Preliminary Drainage Report

Villas at Aspen Trails El Paso County, Colorado

PCD File No.: PUDSP208
SF-21-025

Prepared by:
Kimley-Horn and Associates, Inc.
2 North Nevada Ave
Suite 900
Colorado Springs, CO 80903
(719) 284-7273
Contact: Jared Roberts, P.E.

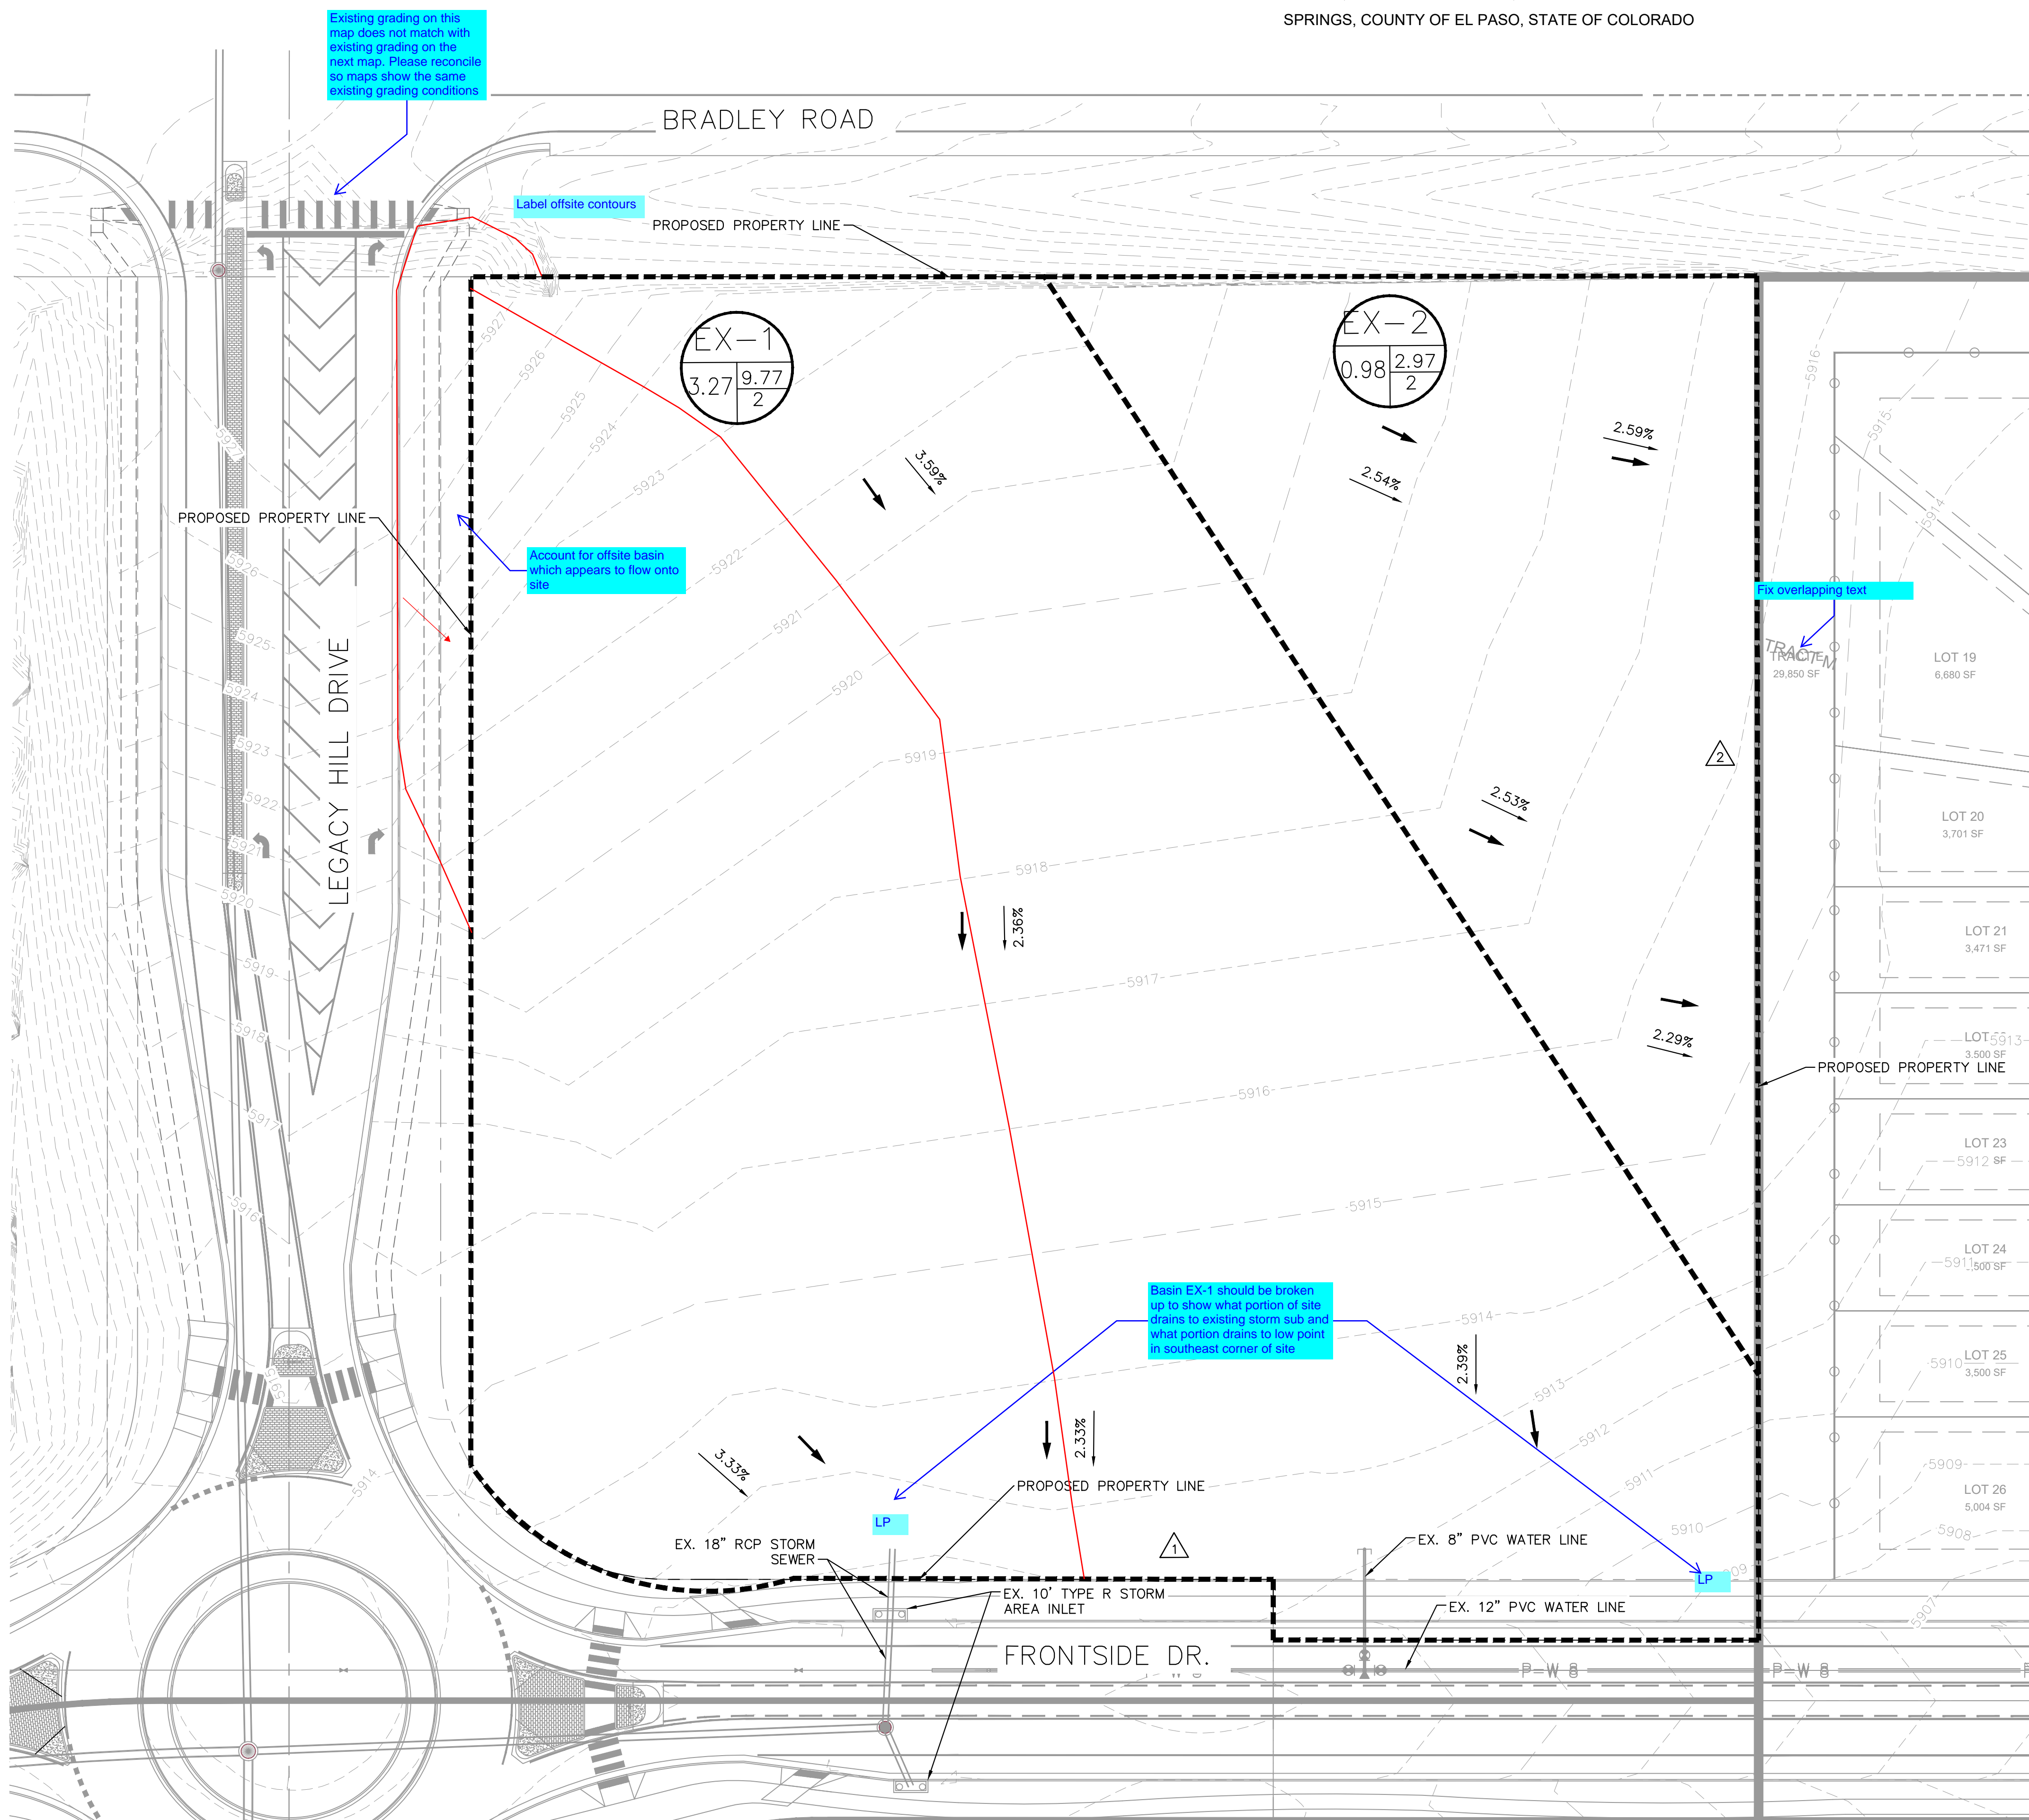
[See comments on drainage maps regarding offsite flows](#)

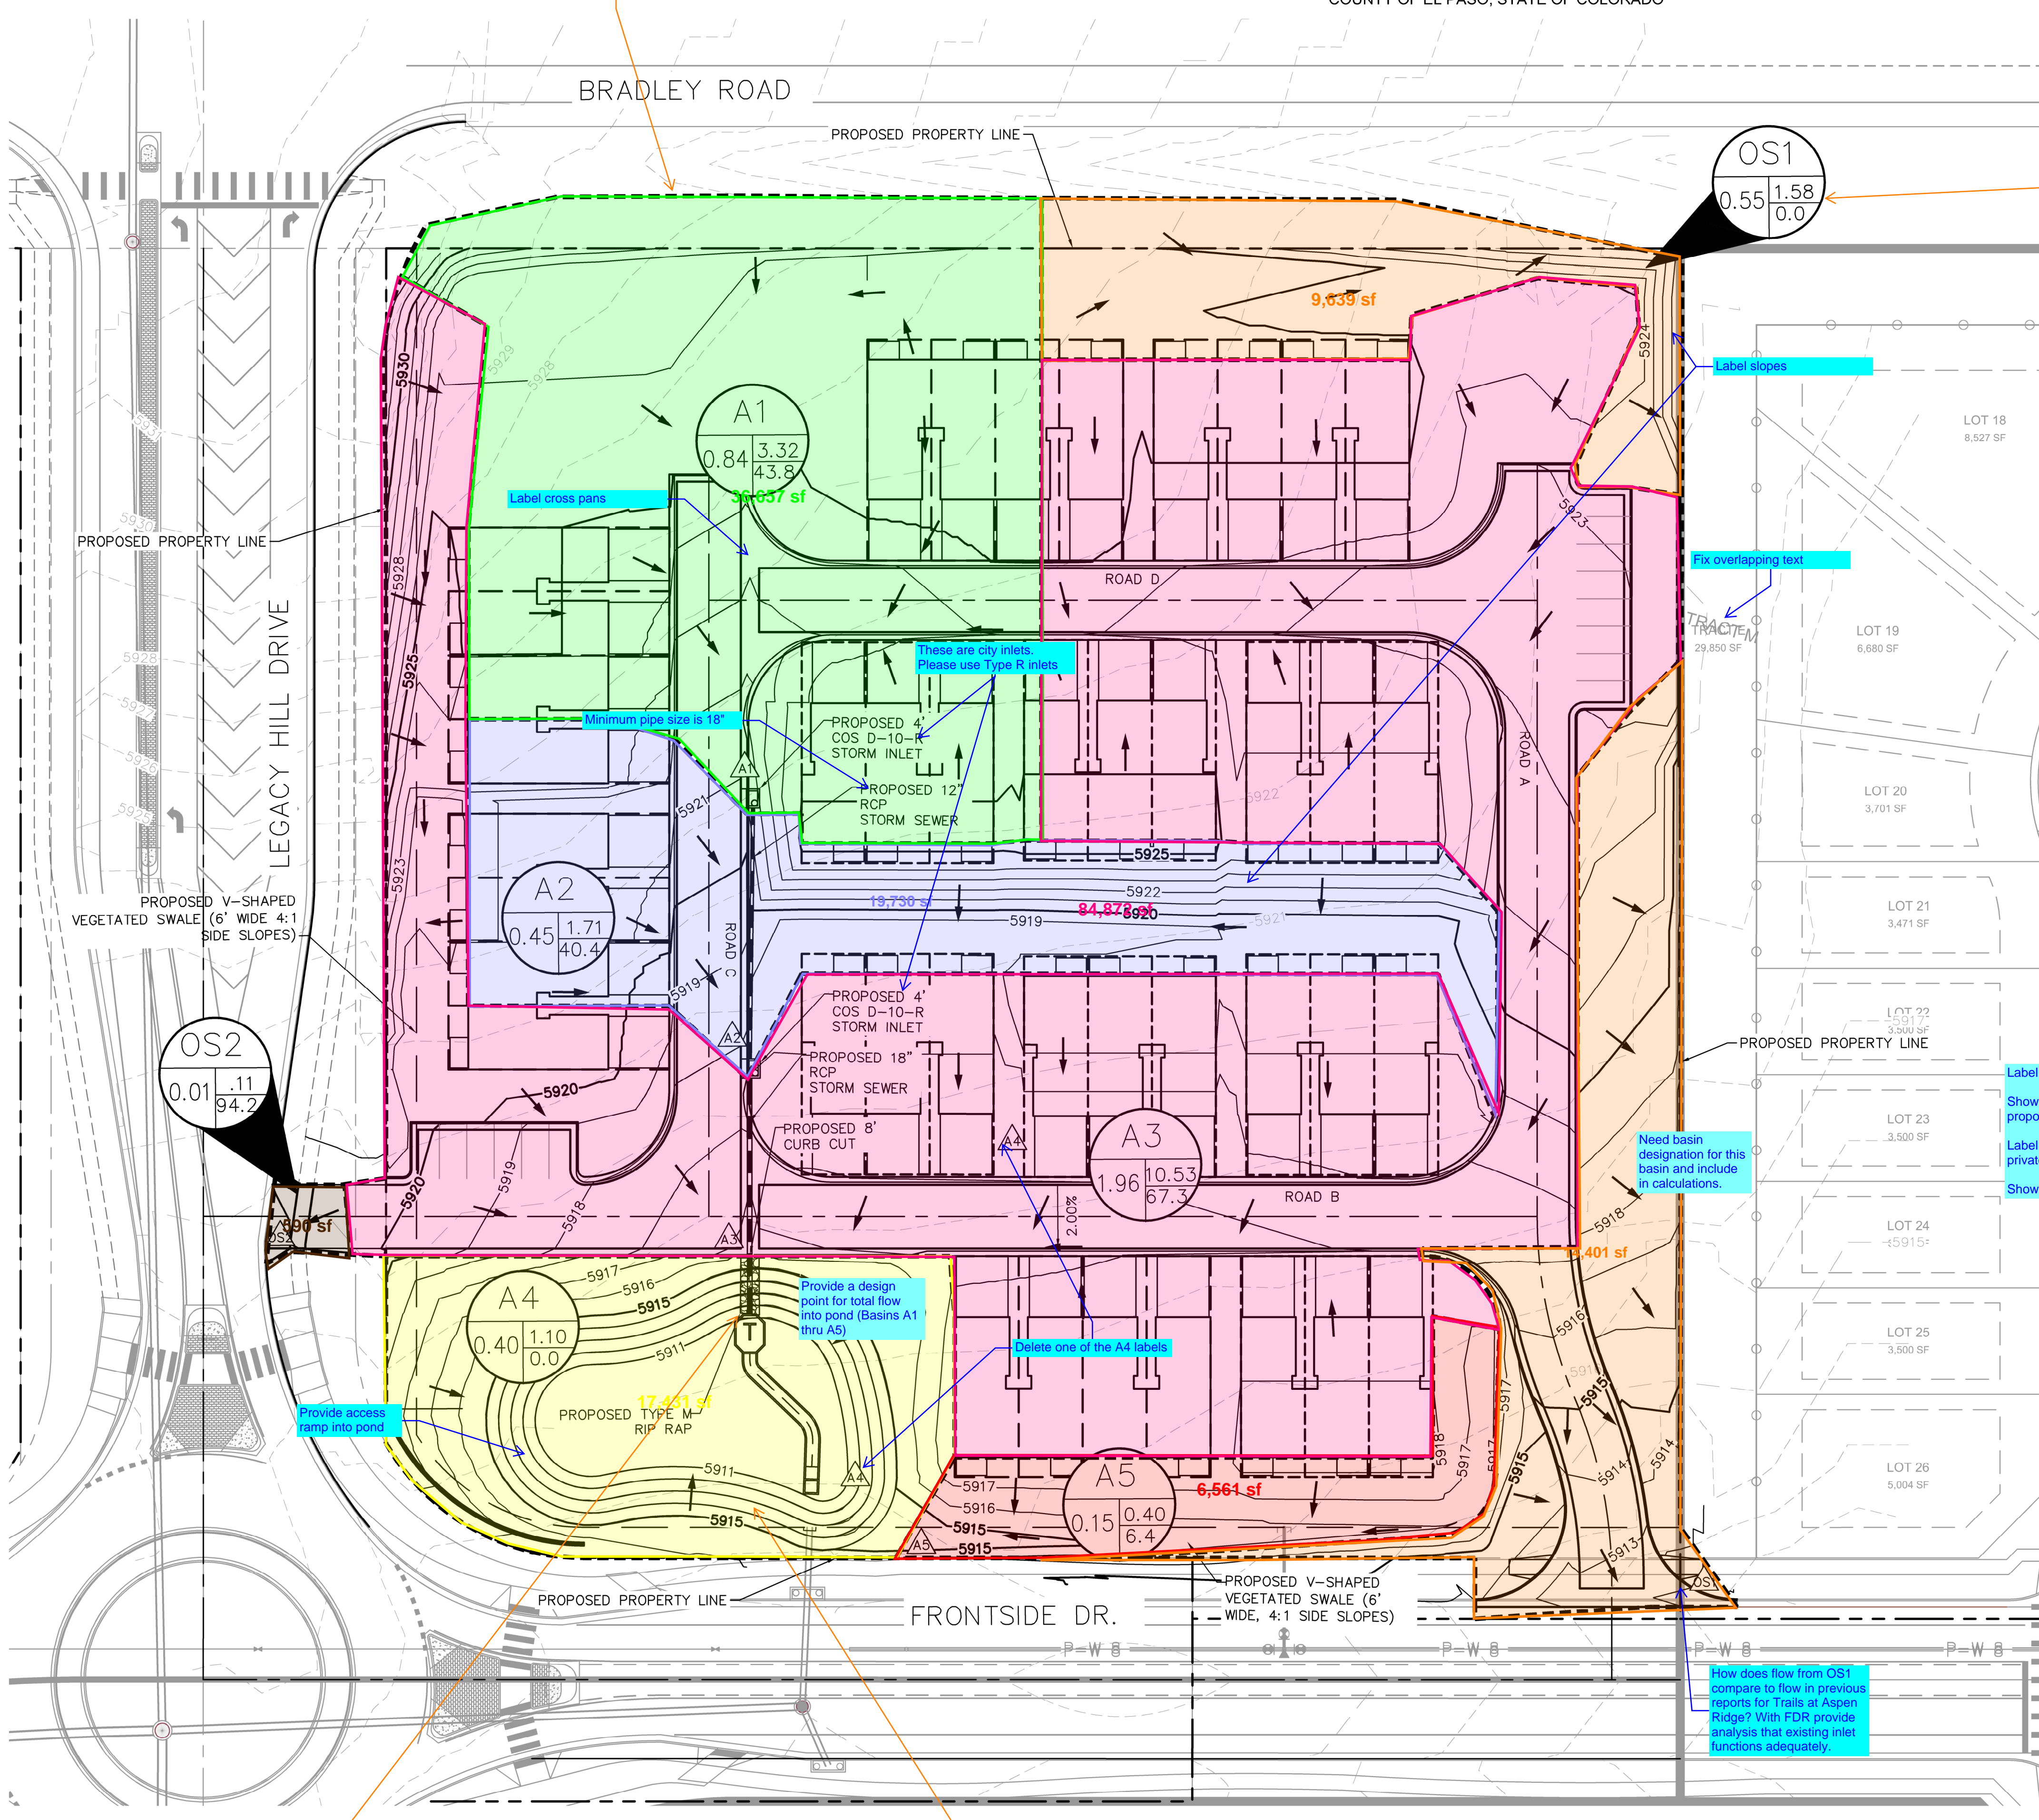
0.55ac includes both orange areas. But since these two areas are not connected and have different discharge point, split them into two different sub-basins

Note for Final Plat (SF) submittal: provide a detail of connection of riprap to the forebay. It should be designed such that the water does not pond behind the forebay wall and thus contribute to erosion around the sidewalls.

The label in the calcs on pg 50 below is "South Pond" add this to the report text and dwgs/maps for consistency.

How does flow from OS1 compare to flow in previous reports for Trails at Aspen Ridge? With FDR provide analysis that existing inlet functions adequately.
